# UNITED STATES PATENT AND TRADEMARK OFFICE

APPLICATION NO.	FILING DATE	FIRST NAMED INVENTOR	ATTORNEY DOCKET NO.	CONFIRMATION NO.
10/823,355	04/12/2004	Robert Martinson	NOVE100042000/NVLS-2898	4719
83586	7590	11/30/2009		
Delio & Peterson, LLC 121 Whitney Avenue New Haven, CT 06510				
EXAMINER				
BAND, MICHAEL A				
ART UNIT		PAPER NUMBER		
1795				
MAIL DATE		DELIVERY MODE		
11/30/2009		PAPER

### Office Action Summary

## **DETAILED ACTION**

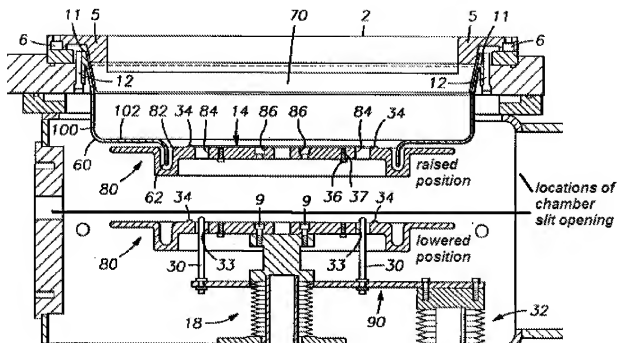
further discloses in fig. 5 the chamber [2] comprises lower, side, and upper walls, a lifter apparatus [90] for moving a pedestal (i.e. elevator) [18] between a lower unloading position and a raised deposition position, and a sputter target [70] above said pedestal [18]. Tepman et al also discloses that the pedestal shield [82] is attachable to the pedestal [18] (col. 6, lines 16-21). Fig. 5 further depicts the pedestal [18] having an extended segment (i.e. pedestal shield) [82] that is movable between the raised position and lowered position, with said extended segment [82] having an outwardly and downwardly extending portion surrounding and extending from said pedestal [18] toward the chamber [2] lower walls and an outwardly and upwardly curving end extending toward said chamber [2] side walls. Fig. 5 also depicts a sidewall shield [60] comprises a cylindrical portion [100] that extends around and within the chamber sidewalls along with downward from an upper portion, said sidewall shield [60] having a curved inwardly and downwardly extending portion with a lower end [62] disposed below an upper portion of the pedestal shield [82] when said pedestal [18] is raised. Fig. 5 further depicts that the lower end [62] is above the pedestal [18] when said pedestal [18] is in the lowered position a distance sufficient to permit a wafer (i.e. substrate) to be horizontally loaded onto said pedestal [18] via slit valve-controlled opening in chamber wall (col. 5, lines 20-49), with said pedestal shield [82] and said sidewall shield [100] cooperating when the pedestal [18] is in the raised position to prevent line-of-sight deposition from the sputter target [70] or gas-scattered transmission of deposition from said sputter target [70] to the side and lower walls of the chamber [2] in addition to preventing line-of-sight or gas-scattered transmission of deposition from sides of the

pedestal shield [82] facing the chamber upper walls to the side and lower walls of said chamber [2]. The cropped figure below of fig. 5 serves to further clarify the raised position, the lowered position, the shields 60], [82] avoiding contact with each other, and a robot blade for horizontally transporting the wafer (i.e. substrate) into and out of the chamber [2].

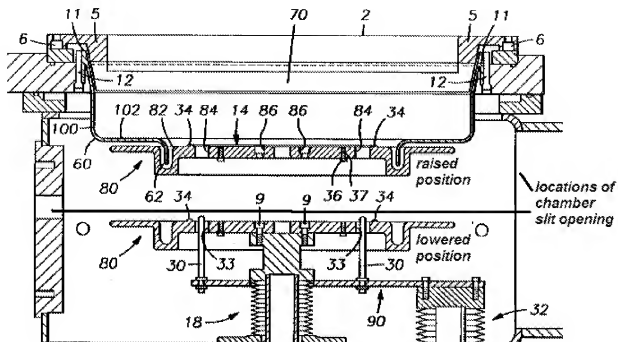
With respect to claims 1-2, 13-15, and 20, Tepman et al discloses an apparatus for full wafer deposition with a sidewall shield arrangement that prevents deposition in the area of a chamber surrounding a substrate (i.e. wafer) (abstract). Tepman et al further discloses in fig. 5 the chamber [2] comprises lower, side, and upper walls, a lifter apparatus [90] for moving a pedestal [80] between a lower unloading position and a raised deposition position, and a sputter target [70] above said pedestal [80]. Fig. 5 further depicts the pedestal [80] having an extended segment (i.e. pedestal shield) [82] that is movable between the raised position and lowered position, with said extended segment [82] having an outwardly and downwardly extending portion surrounding and extending from said pedestal [80] toward the chamber [2] lower walls and an outwardly and upwardly curving end extending toward said chamber [2] side walls. Fig. 5 also depicts a sidewall shield [60] comprises a cylindrical portion [100] that extends around and within the chamber sidewalls along with downward from an upper portion, said sidewall shield [60] having a curved inwardly and downwardly extending portion with a

lower end [62] disposed below an upper portion of the pedestal shield [82] when said pedestal [80] is raised. Fig. 5 further depicts that the lower end [62] is above the pedestal [80] when said pedestal [80] is in the lowered position a distance sufficient to permit a wafer (i.e. substrate) to be horizontally loaded onto said pedestal [80] via slit valve-controlled opening in chamber wall (col. 5, lines 20-49), with said pedestal shield [82] and said sidewall shield [100] cooperating when the pedestal [80] is in the raised position to prevent line-of-sight deposition from the sputter target [70] or gas-scattered transmission of deposition from said sputter target [70] to the side and lower walls of the chamber [2] in addition to preventing line-of-sight or gas-scattered transmission of deposition from sides of the pedestal shield [82] facing the chamber upper walls to the side and lower walls of said chamber [2]. The cropped figure below of fig. 5 serves to further clarify the raised position, the lowered position, the shields 60], [82] avoiding contact with each other, and a robot blade for horizontally transporting the wafer (i.e. substrate) into and out of the chamber [2].
